Subject: St. Lucie Units 1 and 2  
Docket Nos. 50-335 and 50-389  
RAI Reply - License Amendment Request  
Containment Vacuum GOTHIC Analyses and Conforming Changes

## Request for Additional Information MF6980/1-SCVB-01 through 08 Responses

UFSAR FIGURE 6.2-56

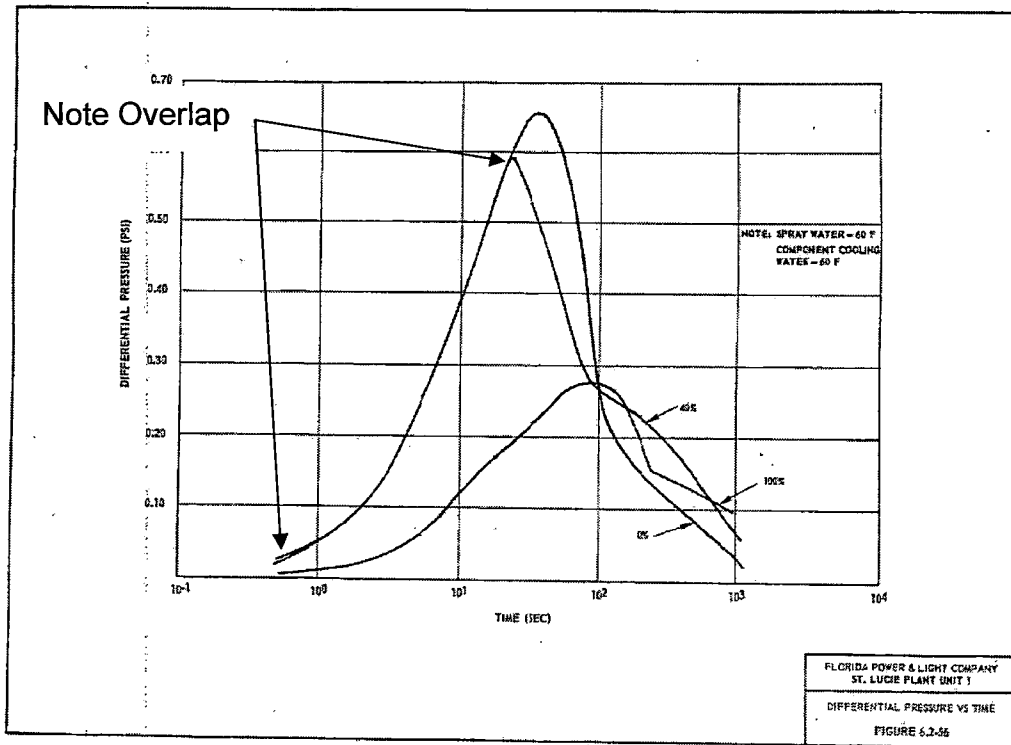
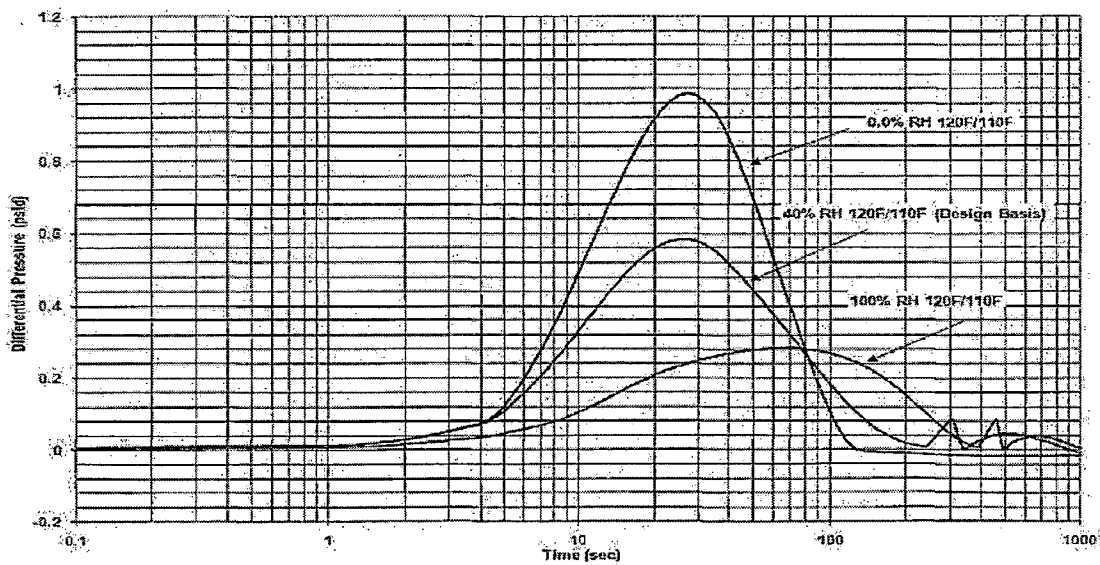
Explain further the conclusion that for Unit 1 the GOTHIC benchmarking results appear more reasonable and conservative than the UFSAR's results.

As shown in the table below, the maximum values of DP(Annulus-Cont.) and DP(Atm.-Annulus) predicted by GOTHIC are in good agreement (i.e. less than  $\pm 6\%$ ) with the UFSAR values except the maximum value of DP (Annulus-Cont.) for Case A (i.e.  $\sim 49\%$ ).

The comparison of UFSAR Figure 6.2-56 and the chart of GOTHIC results below shows some deviation in the trend of differential pressure transient from the annulus to the containment for Case A. Considering that the lower initial containment relative humidity condition should lead to a faster and steeper depressurization in the containment, it can be concluded that GOTHIC prediction seems more reasonable and conservative. Note that the overlapping of the two differential pressure curves of Cases A and B up to approximately 30 seconds as shown in UFSAR Figure 6.2-56 seems less realistic than the GOTHIC results.
